Technical Bulletin / Bollettino Tecnico

ECAM Models

### New grinder with integrated thermal protector on ECAM models

Grinder pn: AS00002955

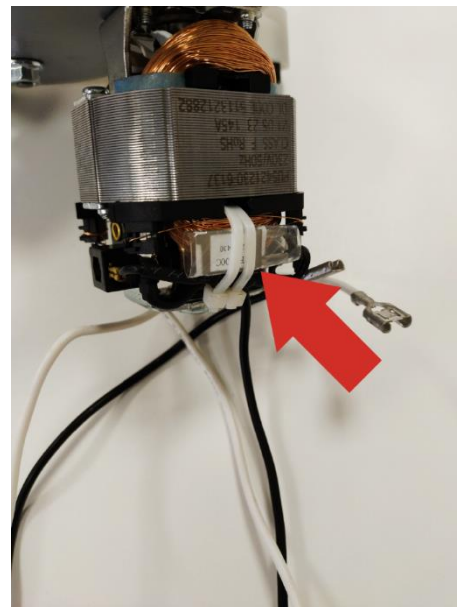
We inform you that it is available in DLS the new grinder with integrated thermal protector pn **AS00002955**.

POSITION OF BROWN CABLE WITH FUSE  
POSIZIONE DEL CABLAGGIO MARRONE CON FUSIBILE

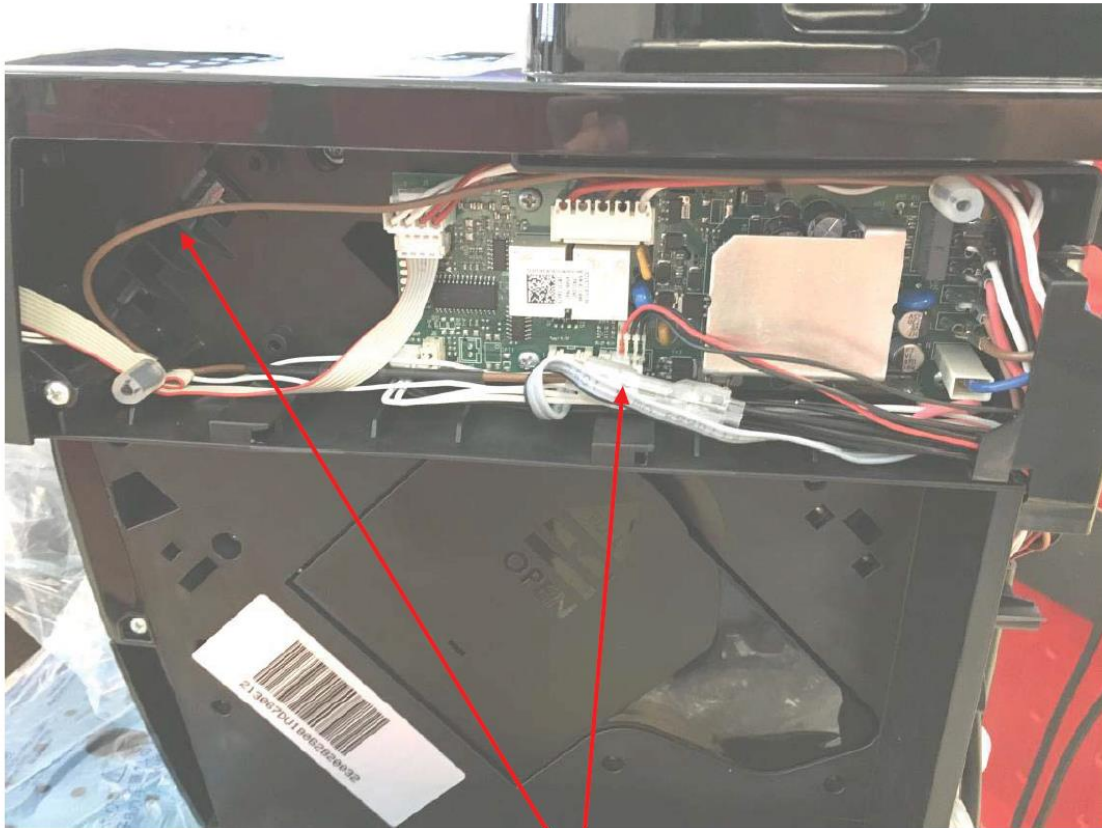
In case of replacement of a grinder with fuse placed along the wire it is necessary to remove the wire itself and connect the new grinder directly on the main PCB.

Macinino codice: AS00002955

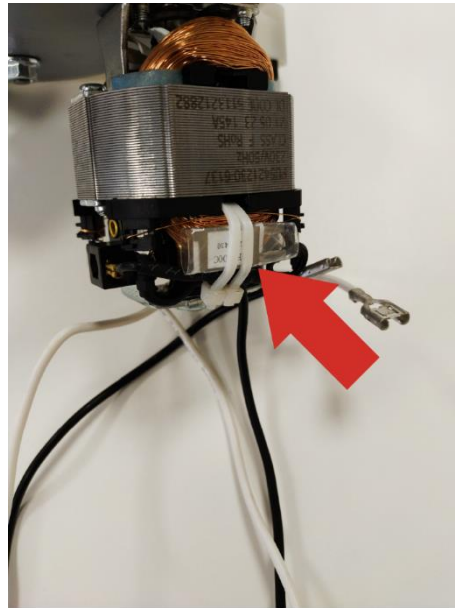
Vi informiamo che è disponibile in DLS il nuovo macinino con protettore termico integrato a codice **AS00002955**.

POSITION OF BROWN CABLE WITH FUSE  
*POSIZIONE DEL CABLAGGIO MARRONE CON FUSIBILE*

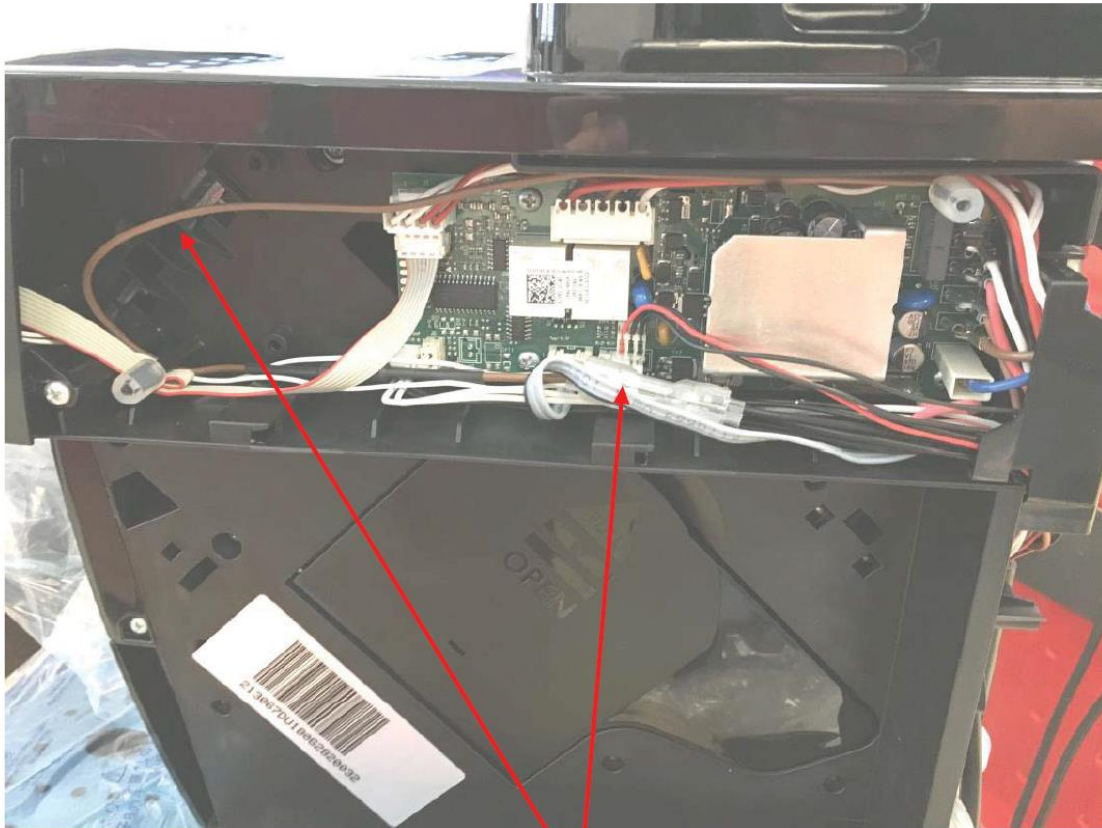
In caso di sostituzione di un macinino con fusibile posizionato lungo il cablaggio è necessario eliminare il cablaggio stesso e collegare il nuovo macinino direttamente alla main PCB.
